DIGITALEUROPE Comments on the Draft Ecodesign Regulation on Electronic Displays, Notified to the WTO on 21st of December 2016

Brussels, 3 February 2017

Figure 1: Power consumption of Monitors with screen resolution below 3840 × 2160 pixels compared to the updated power consumption limits for HD displays proposed by CLASP. Source of monitor data: 2016 DIGITALEUROPE database.

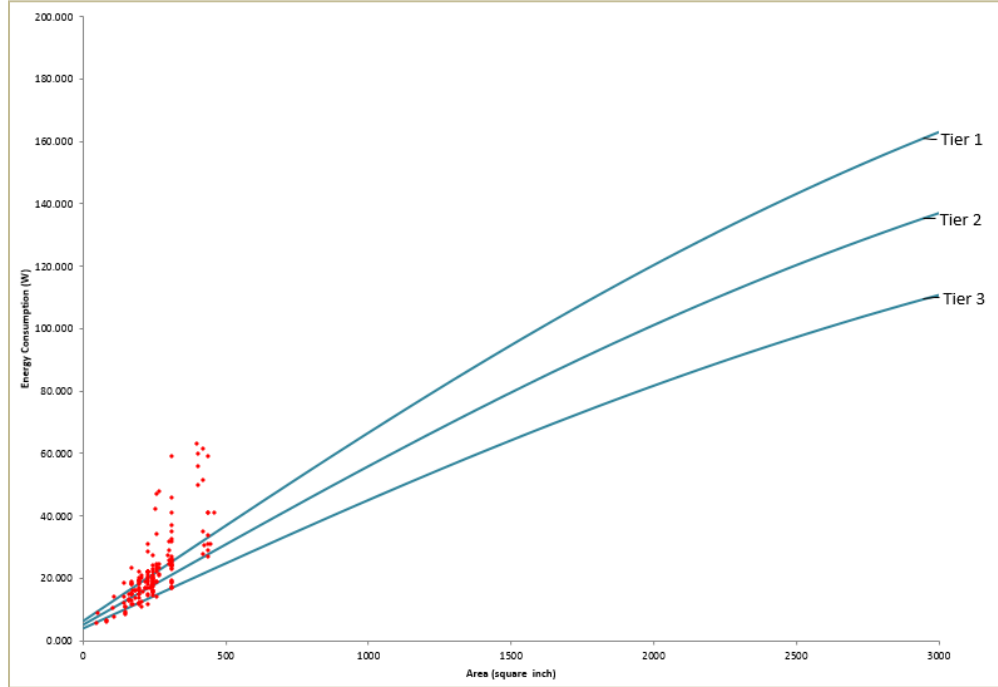
1. **The Commission proposal expanded the scope of the regulation to PC monitors, but CLASP does not take into account the current energy performance of monitors when analyzing the level of ambition in the Commission proposal.** The 2016 DIGITALEUROPE database¹ shows that for monitors (especially for those with smaller screen sizes) it is already problematic to meet the Commission proposed targets, mainly because of the power supply converting loss combined with picture process power, which result in a relative higher energy consumption from non-display electronics as a percentage of total energy consumption. Further strengthening of the proposed requirements, as suggested by CLASP, would have an even more disproportionate effect on monitors, resulting in a significantly large number of models being removed from the EU market as can be seen below:

Figure 2: Power consumption of Monitors with screen resolution equal to and above 3840 × 2160 pixels compared to the updated power consumption limits for UHD displays proposed by CLASP. Source of monitor data: 2016 DIGITALEUROPE database.

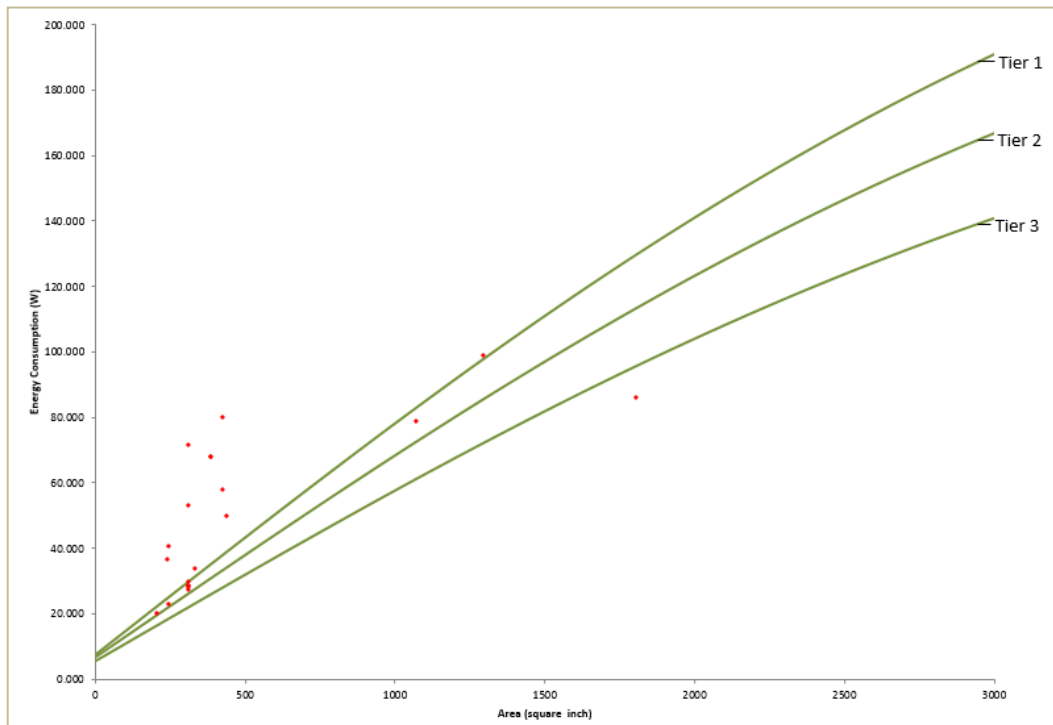
In addition, it is important to differentiate energy requirements for normal displays from those for specialty displays (for example: Large Displays with Touch, Displays > 40", Medical or Gaming Displays, etc.). Exemption criteria should be set in place for some of these special types of displays.

Figure 3: Power consumption of ENERGY STAR Certified Monitors compared to the power consumption limits for HD displays proposed by CLASP. Source of monitor data: 2016 DIGITALEUROPE database. Only monitors with screen resolution below 3840 × 2160 pixels have been taken into account.

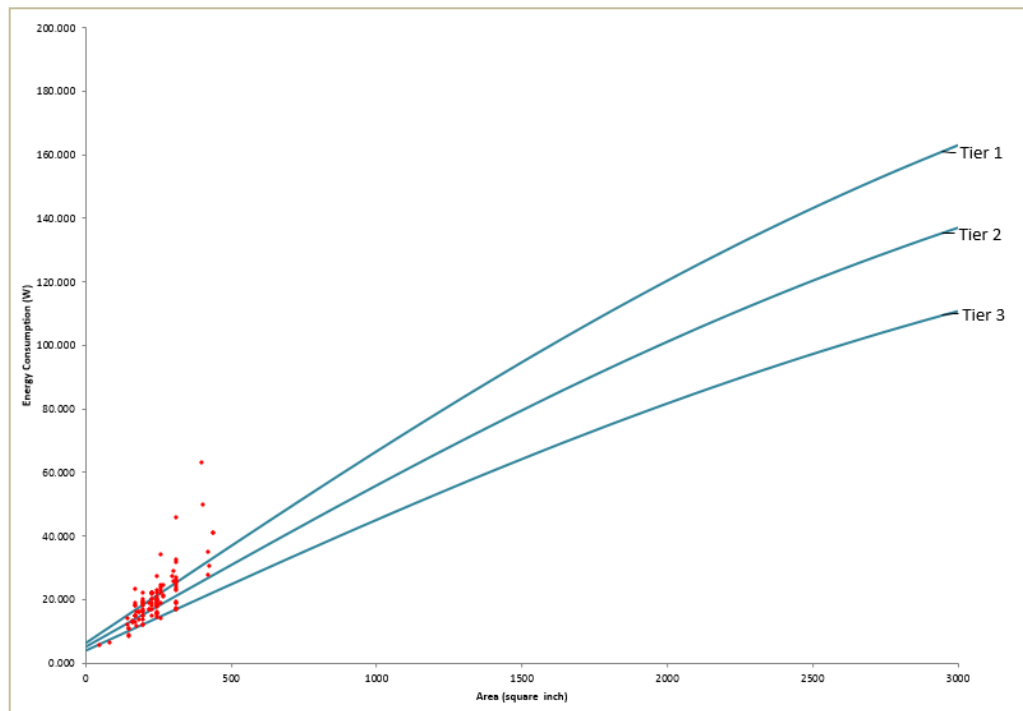
2. It should also be pointed out that the CLASP recommendation takes a step back from the necessity of harmonizing product energy efficiency requirements at a global level. By implementing the limits proposed by CLASP, **displays that have been certified with ENERGY STAR in the US may not even be allowed on the EU market**, as can be seen below in the case of ENERGY STAR certified monitors.
